SUBJECT: RFI FOR THE SP FOR IMPLEMENTING INTERIM MEASURES AND BMPs AT TA-49, PRSs 49-001(b,c,d, and g) (FORMER OU 1144, FU 5)

**Response to Request for Supplemental Information
for the Stabilization Plan (SP) for Implementing Interim Measures and
Best Management Practices at PRSs 49-001 (b, c, d, and g)
Los Alamos National Laboratory (LANL) EPA I.D. NM0890010515**

ATTACHMENT A
CONTINGENCIES FOR REDUCING SOIL MOISTURE CONTENT
AT POTENTIAL RELEASE SITES 49-001(b, c, d, and g)

Figure 2-1. Monitoring hole locations at Area 2.

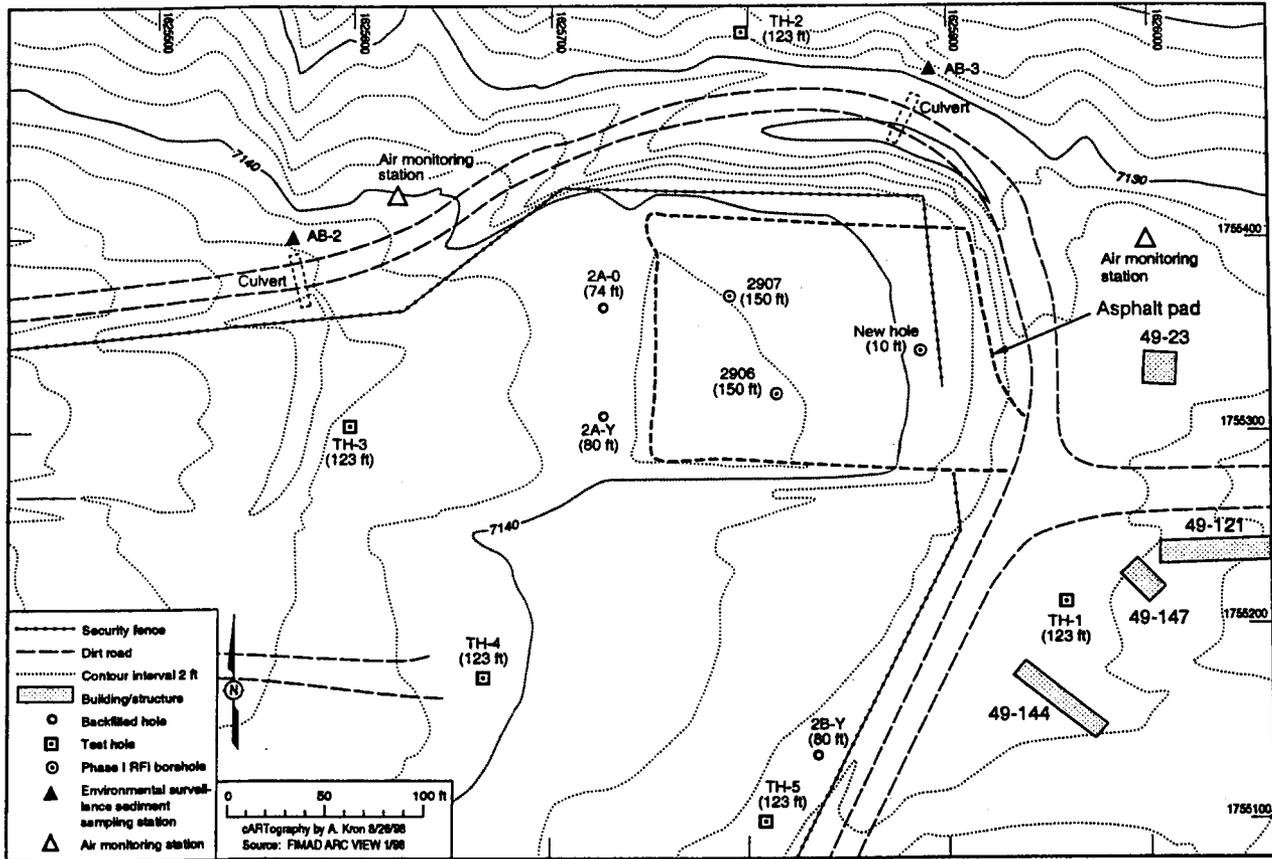
2. *LANL shall provide a sampling schedule for the moisture content beneath the temporary cover, including fill and clay, to determine if the cover is effective.*

3. *LANL shall provide a contingency plan (with schedule) that describes an alternate solution if an increase in moisture content under the temporary cover, including fill and clay, occurs.*

2. A sampling schedule is provided in the contingency document (Attachment A) requested in NMED's third comment (below). This schedule provides an elaboration of the monitoring program information provided in Section 6.0 of the stabilization plan and calls for a three-part monitoring effort. First, monitoring will be performed in the surface soils and the soil/tuff interface on a monthly basis at

The new hole (designation to be determined) will be located approximately 20 feet east of Shaft 2-O and 10 feet inside the current site fence. It will be installed to a depth of about 4 feet beneath the soil/tuff contact, which is estimated to be about 10 feet beneath the present ground surface. The new hole will be installed at the time the site stabilization measures are implemented. Installation will proceed cautiously and although not expected, if elevated radiation levels are encountered the hole may be moved to another location. The hole will be completed with a sealed PVC casing in tight contact with the borehole wall. This design will provide a durable installation with no annular space for vertical water movement.

Of the three monitoring holes on the pad, hole 49-2907 is located in the northwestern, upgradient part of the pad, hole 49-2906 is located in the south-central part of the pad, and the new hole is located in the east-central, downgradient part of the pad. Holes 49-2906 and 49-2907 are located approximately 25 feet from the nearest shafts where no concrete caps are believed to be present and may therefore be in areas of better vertical drainage where the moisture content of the fill materials beneath the asphalt is lower. The new hole is located downgradient of shaft 2-O where standing water was found above a concrete cap at a depth of 24 inches during RFI sampling in April 1998. The concrete cap may impede vertical drainage, and the new hole may be in an area where the moisture content of the fill materials is higher. These three holes are appropriate for conservatively determining representative average conditions because less than a third of the pad is believed to be underlain by concrete caps. The moisture content of the native soil underlying the fill materials and concrete caps is expected to be elevated throughout the pad.
